DeKalb County Historic Preservation Commission

Staff Report

- I. 906 Lullwater Road, Maureen Meulen. Modify a previous COA to construct a rear addition, renovate a nonhistoric addition on the front façade, and construct a covered outdoor area on the rear of the property. **1247761**

PROPOSED SOUTHWEST ELEVATION

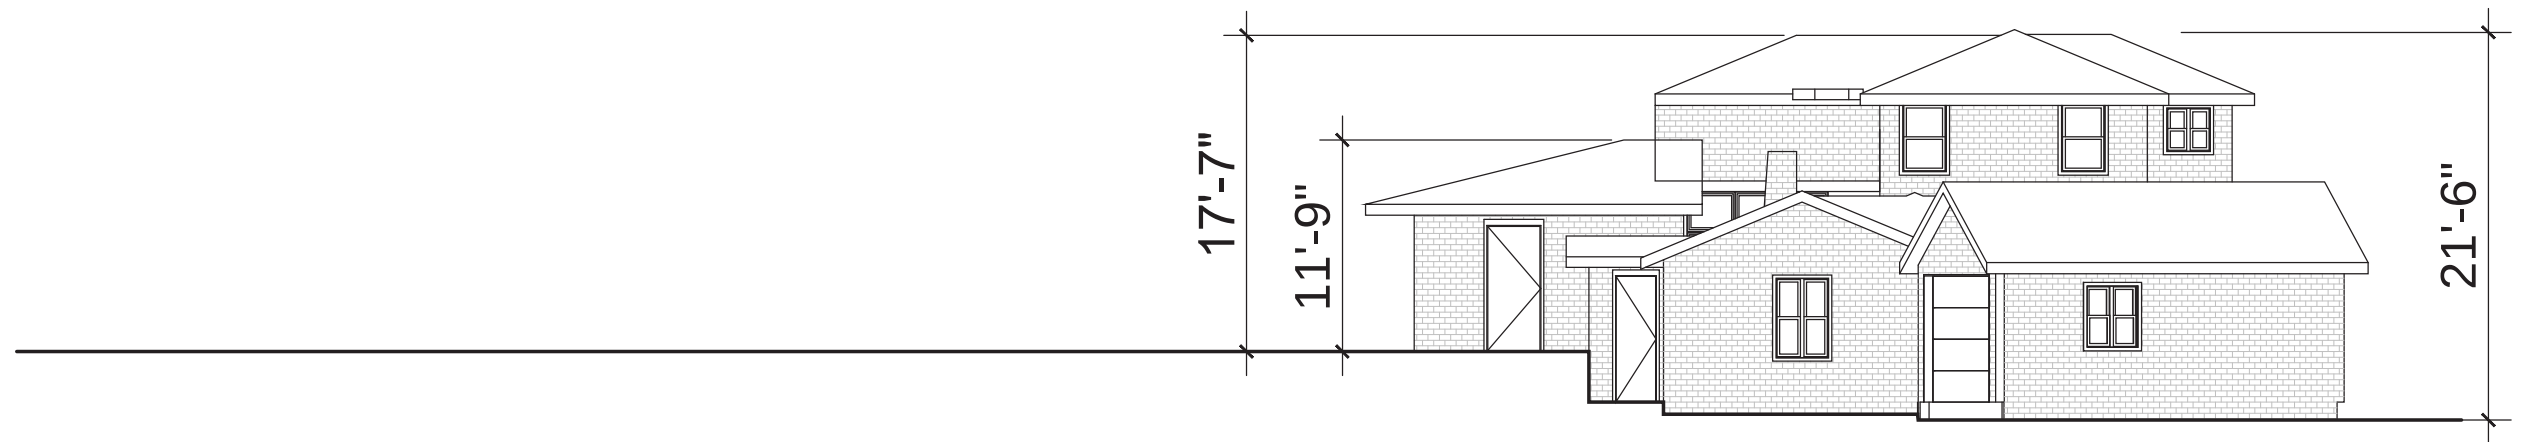
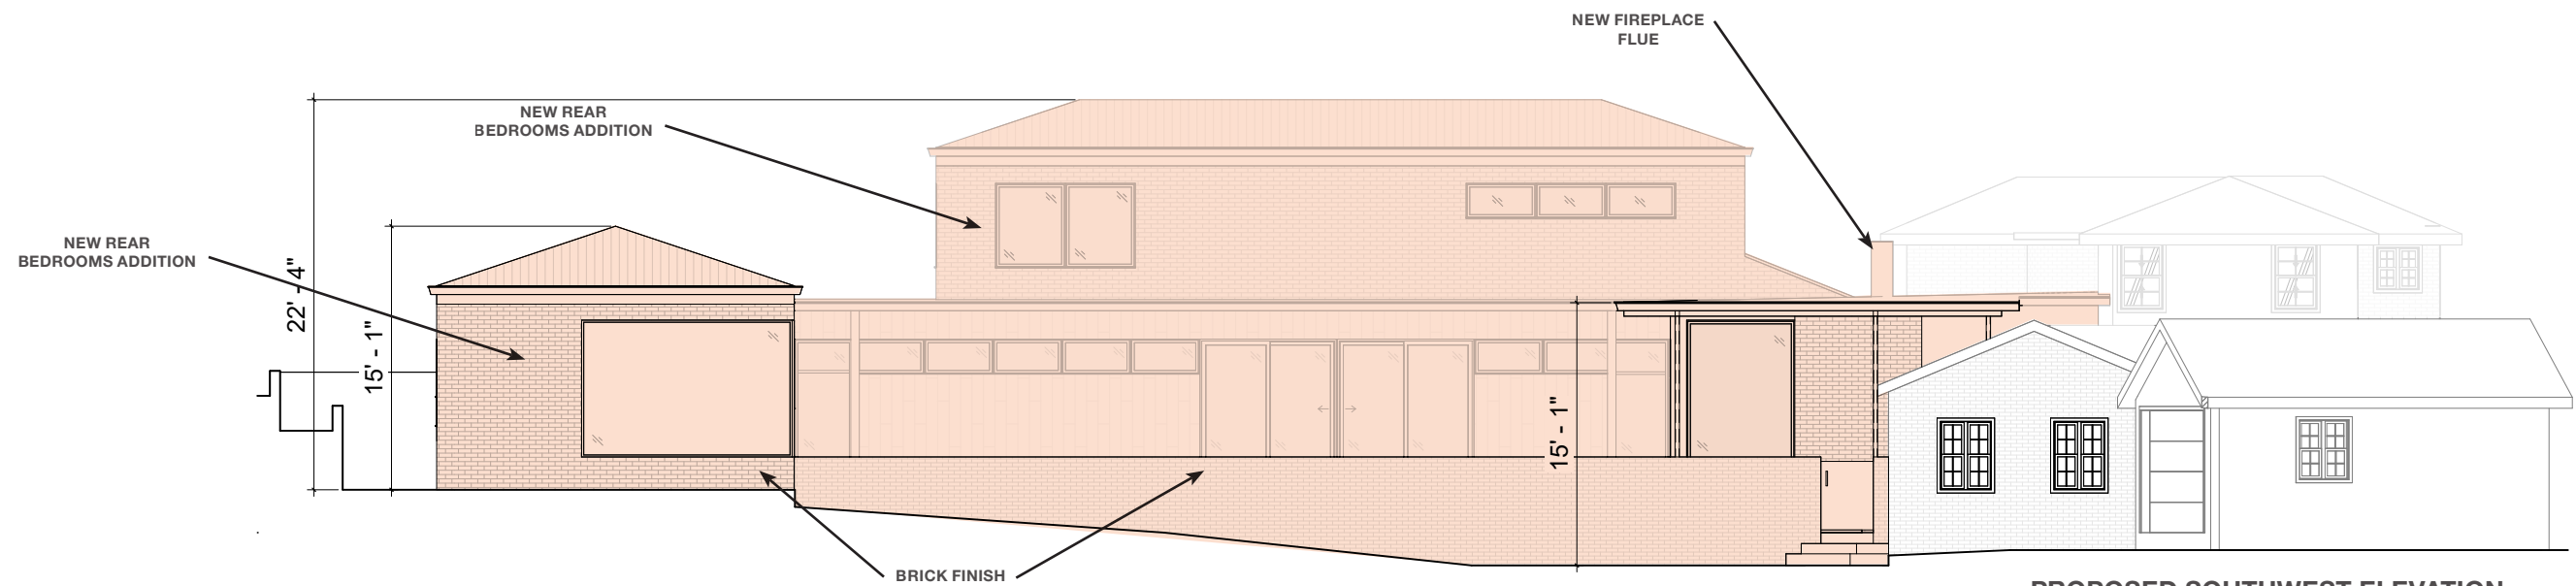
The applicant provided revised drawings for the proposed modifications after agreeing to defer the application from the previous month's meeting. The revised drawings show that the proposed rear additions will now match the height of the existing two-story portion of the house and will not be visible from the Right of Way. The enclosing of the front walkway and front entrance will be completed with a series of single-pane floor-to-ceiling windows, the roof line above the main entrance will not be modified, and the roofing above the walkway will be modified to match the roof ridge of the main house. A double-hung 6-over-6 window will be installed on the front façade of the front-gable portion of the house, matching the existing window on the structure.

1. Construct a two-story and a one-story addition on the rear of the house. Previously, a single-story addition was approved to be constructed on the rear of the historic house after the demolition of a smaller nonhistoric rear addition; the applicant proposes that in order to prevent requiring a variance due to the stream buffer that the addition on the rear of the property be a two-story addition with a one-story addition on the rear. The proposed two-story addition will measure 22' 4" in height from grade to the roof ridge and will be taller than the existing tallest portion of the main house, which measures 21' 6" in height from grade to the roof ridge on the front of the property and 17' 7" on the rear of the property. The one-story addition on the rear of the two-story addition will measure 15' 1" in height from grade to roof ridge; the previously approved one-story addition measured 11' 9" from grade to roof ridge. The combined square footage of the rear addition will measure 2,820 square feet. The two-story addition and one-story addition will be constructed with a hipped metal roof, brick and wood siding to match the main structure, and aluminum-clad wood windows with minimal divided lites. The rear addition will be partially visible from the Right of Way from Lullwater Road and will be visible from the Right of Way from The By Way.

PROPOSED SOUTHEAST ELEVATION

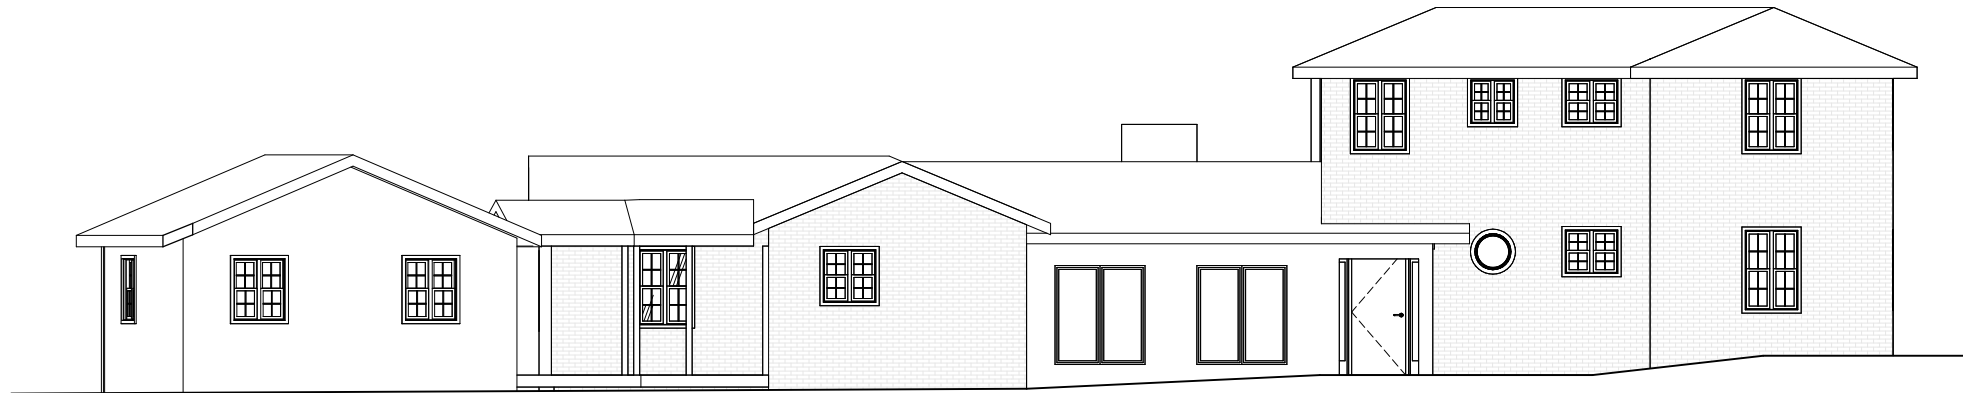
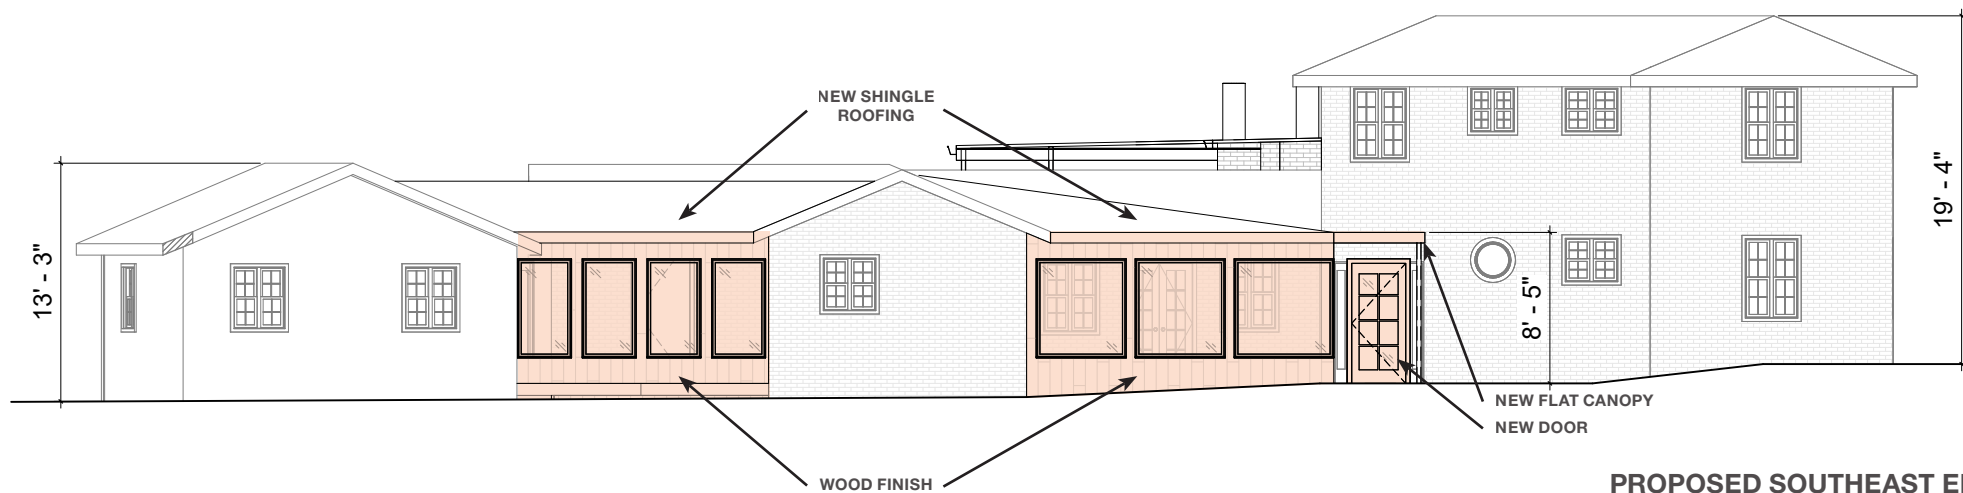
2. Construct a covered outdoor kitchen on the rear of the house. A 16'x16' outdoor kitchen will be constructed on the center of the rear façade of the house. The outdoor kitchen will be constructed with a flat metal roof supported by wood columns reaching 15' 1" in height, a concrete and paver patio, and a metal fireplace flue. The canopy metal roof will be visible from the front façade of the house and will be visible from the Right of Ways of Lullwater Road and The By Way.

FRONT FACADE (VIEW 9)

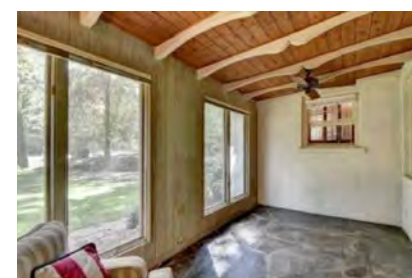
4. Renovate the nonhistoric addition on the front façade of the house. The applicant proposes renovating the nonhistoric addition on the front façade of the house that was previously approved to be demolished and remove to expose the historic front façade and main entry. The current two sets of sliding vertical windows on the addition will be removed and replaced with three large teal frame dual pane windows with no divided lites. The existing siding on the addition will be removed and replaced with new wood siding, the pitched asphalt shingle roof above the addition will be removed and a hipped asphalt shingle roof will be installed, and the roof ridge over the main entrance will be removed and replaced with a flat canopy. The existing solid wood front entrance door will also be removed and replaced with a 2x4 divided lite door.

The proposed modifications to the front façade of the historic house, including enclosing the covered walkway and the renovation of the nonhistoric addition, do not meet the guidelines for the preservation of architectural details, original entrances and porches, and the roof form of historic houses for the Druid Hills Local Historic District.

THIS IS AN ANACHRONISTIC ADDITION WHICH CLUTTERS UP THE ORIGINAL FACADE. WE WILL BE REBUILDING THIS AS A WOOD AND GLASS MORE OPEN ENCLOSURE THAT CONCEALS LESS OF THE HISTORIC BUILDING.

PROPOSED SOUTHWEST ELEVATION

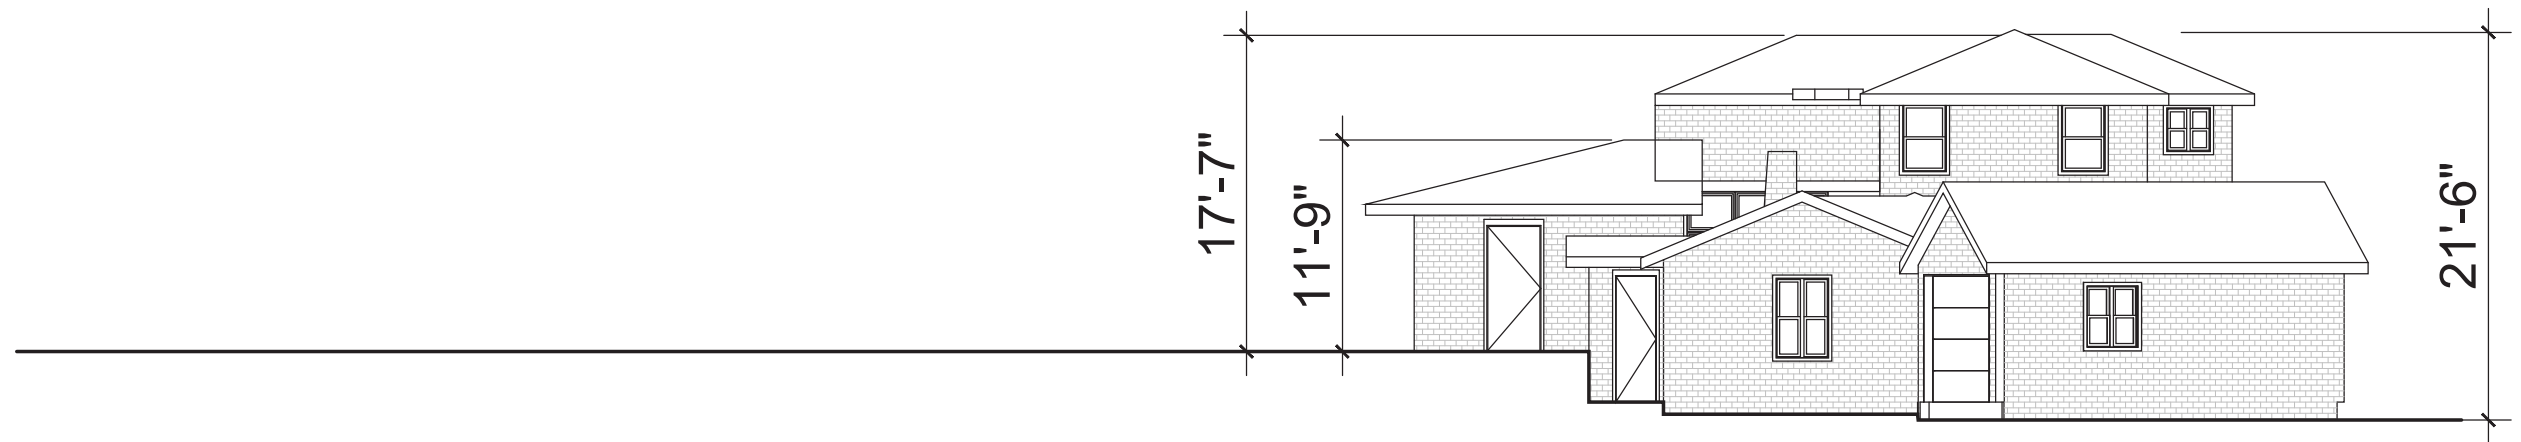
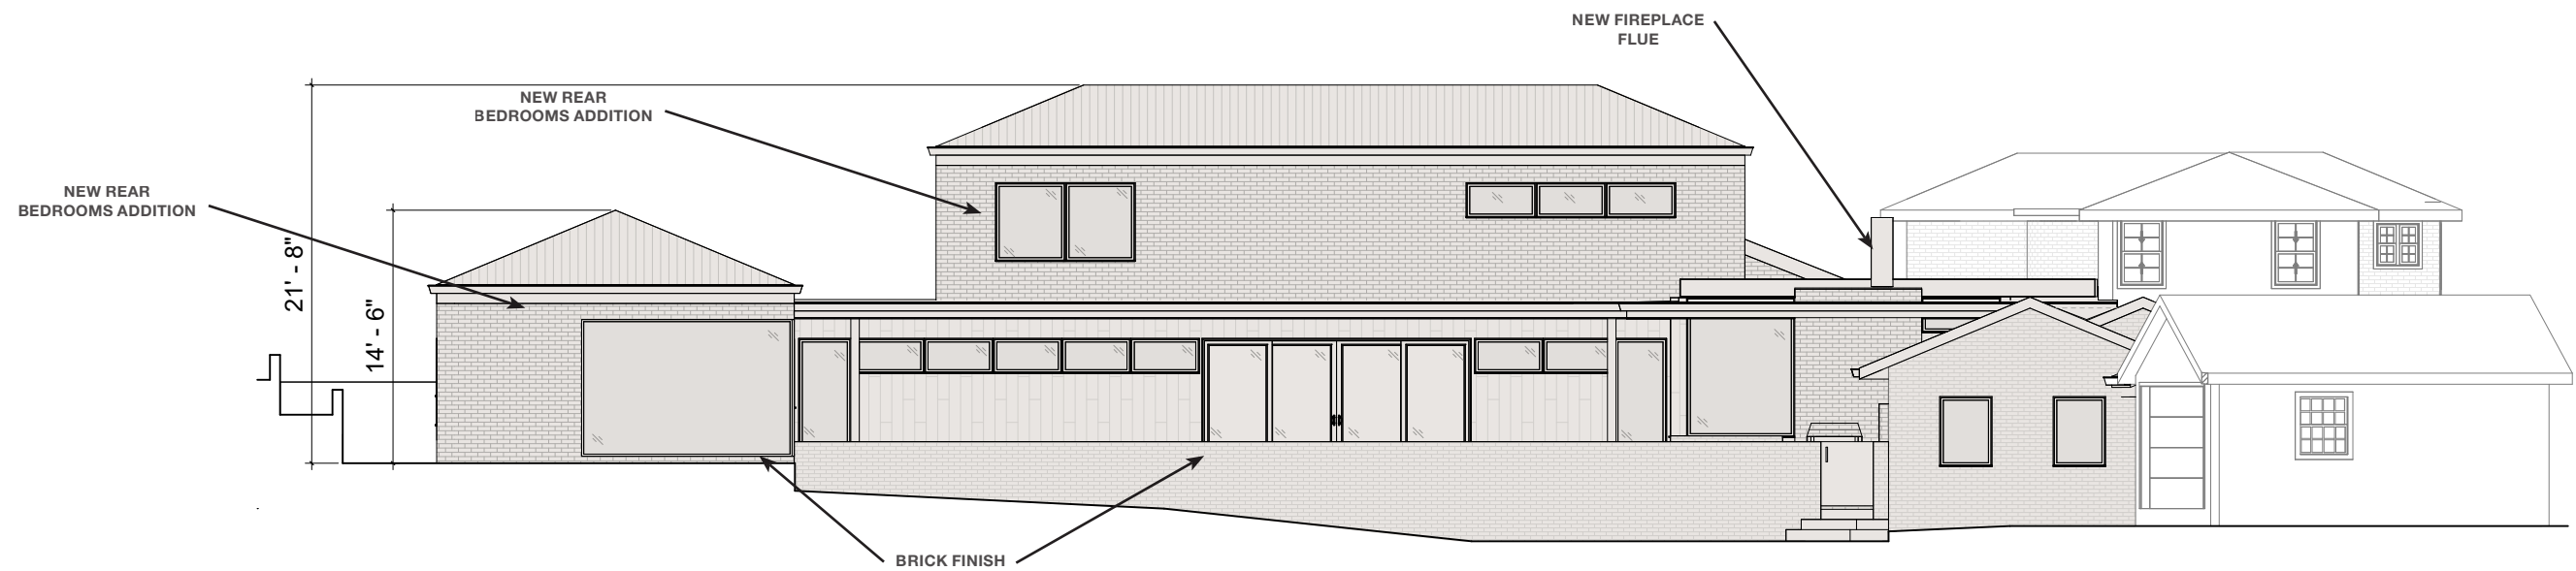
These plants will be installed on the Southwest façade of the rear addition, facing towards The By Way.
